Subject: Parachute and Actuators Being Presently Tested at
El Centro

SUBJECT: PARACHUTE & SEAT TEST PROGRAM - EL CENTRO

1ST Static Ejection Seat Test

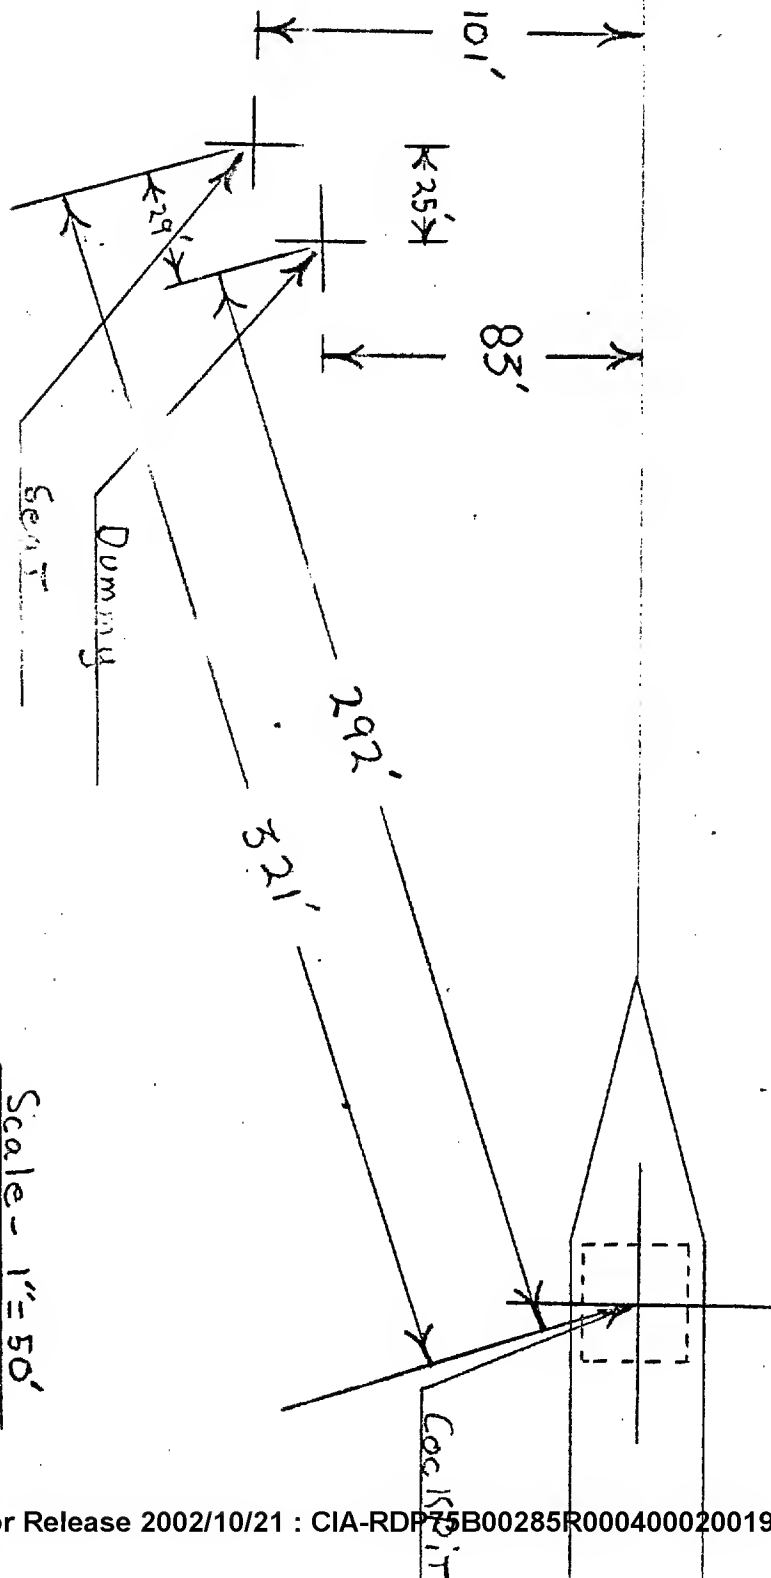
SPIN ON THE DROGUE WAS OBSERVED ON WHIRL TESTS & ON ONE DUMMY DROP WHERE SPIN AT LOW ALTITUDE (4000-5000 FT) WOUND UP THE LINES & COLLAPSED THE DROGUE. LOW ALTITUDE ON THE DROGUE IS NOT VALID BUT ABOVE 15M FT. COULD BE CRITICAL. FORTHCOMING HIGH ALTITUDE JUMPS WILL ALSO CHECK THIS CONDITION.

- ① TRAJECTORY CAMERA'S - (2) FIXED. 1.- FLASH BULB FOR TIME ZERO. 2.- No TRUCKS/VEHICLES IN VIEW.
 (340' X 400' HIGH) 200 FRAME/SEC? 20 F/S HULCHER?

A.- HULCHER 20 FPS, FROM 0 TO BURN-OUT, (70 FT)
 (FOR ACCELERATION & THRUST)

A.- LAUNCH - BURN-OUT - SEPARATION - STRING OUT -
 INFLATION, TOUCH DOWN.
 (FOR DETAIL ON ROTATION - BELTS COMING LOOSE, ETC)

- ④ FOLLOW DUMMY & CHUTE - NOT SEAT
